Rev	Date	Revision	By	Chk.
A	-	CONCEPT		
B	01/10/2024	DA Submission		
C	13/12/2024	RFI DA Issue		
D	12/03/2025	RFI DA Issue		
E	23/07/2026	Minor Change Application

Schedule of Amendments

- Relocate egress stair in the basement from Watson Street to Abbott Street
- Relocate booster assembly from Watson Street to Abbott Street
- Loss of 1 car space in basement carpark
- Paving over basement
- Wall straightened and window updated to suit
- Windows repositioned
- Building line at private pool terrace extended towards Abbott Street
- Building line at communal pool terrace extended towards Watson Street
- Pool deck FFL increased
- Roof height increased
- Mechanical risers & exhaust to roof added
- Balustrade changed to glass panels
- Lift overrun height reduced
- Privacy screens at the side boundary updated to match screens on balconies
- Screen wall added to passage between pools

Project
Multi-Residential Apartment Building
12 Abbott St, New Farm QLD
4005

Floor Plan - Basement

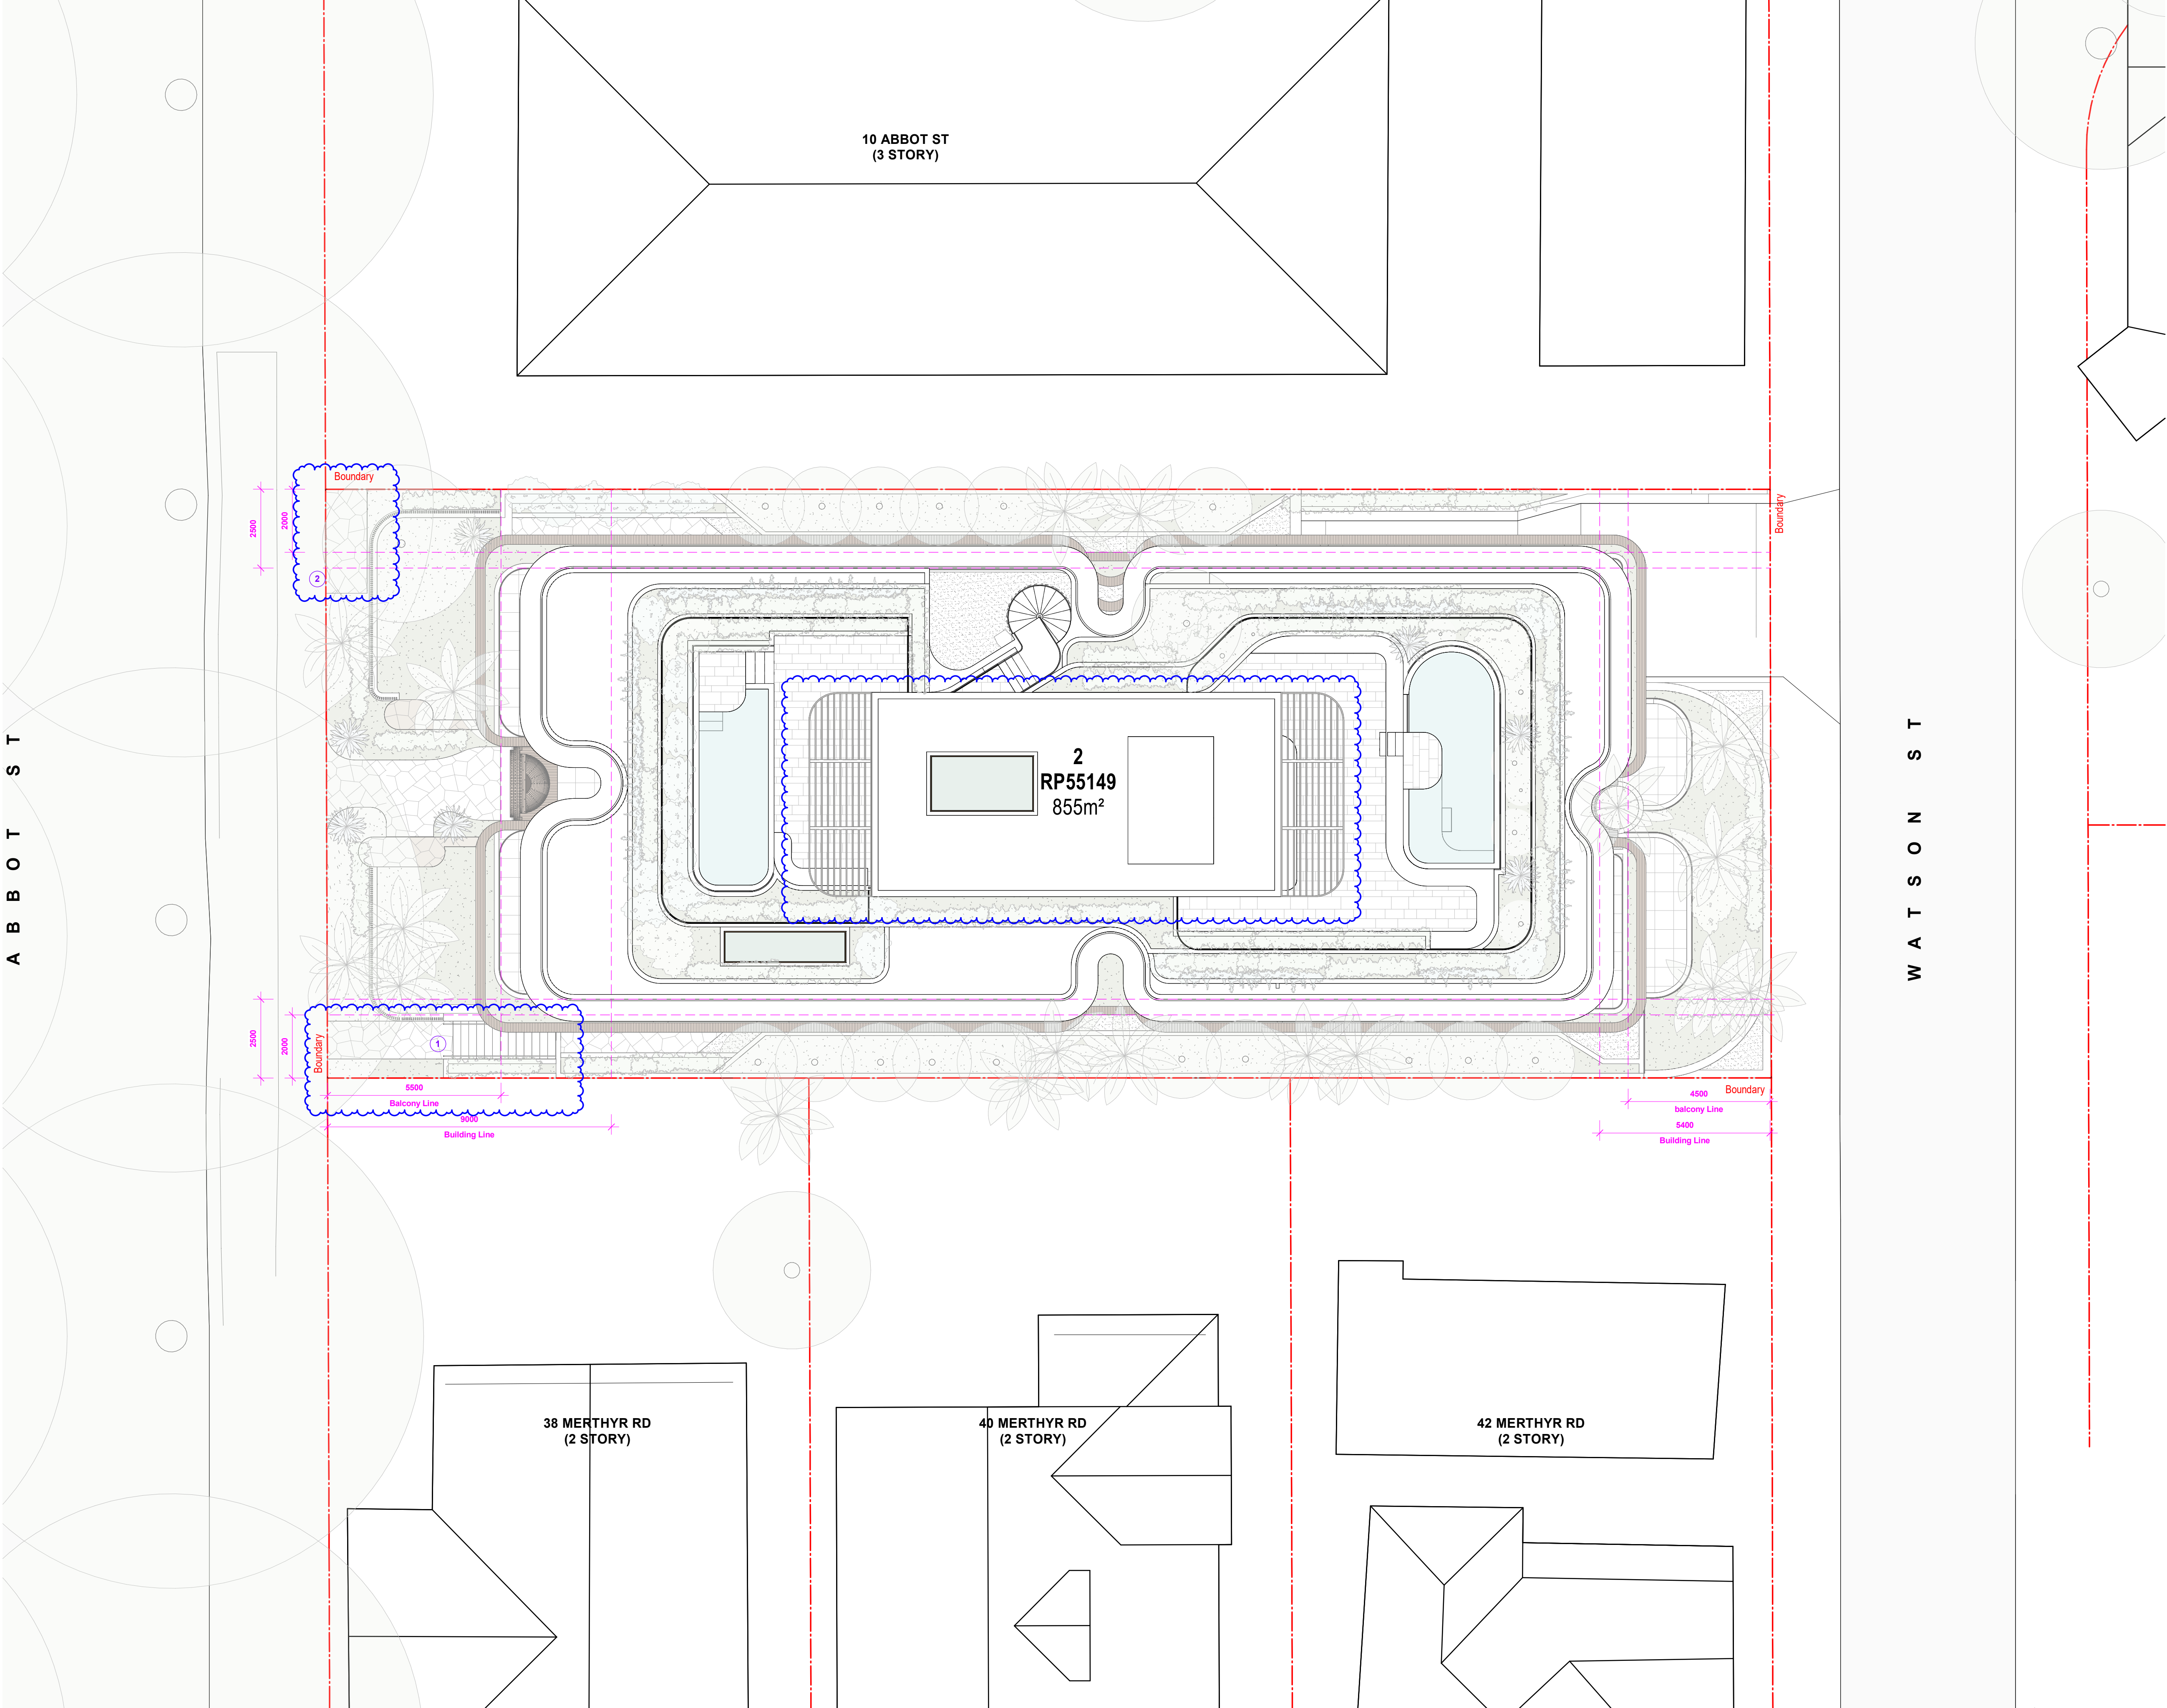
- Relocate egress stair in the basement from Watson Street to Abbott Street
- Relocate booster assembly from Watson Street to Abbott Street
- Loss of 1 car space in basement carpark
- Paving over basement
- Wall straightened and window updated to suit
- Windows repositioned
- Building line at private pool terrace extended towards Abbott Street
- Building line at communal pool terrace extended towards Watson Street
- Pool deck FFL increased
- Roof height increased
- Mechanical risers & exhaust to roof added
- Balustrade changed to glass panels
- Lift overrun height reduced
- Privacy screens at the side boundary updated to match screens on balconies
- Screen wall added to passage between pools
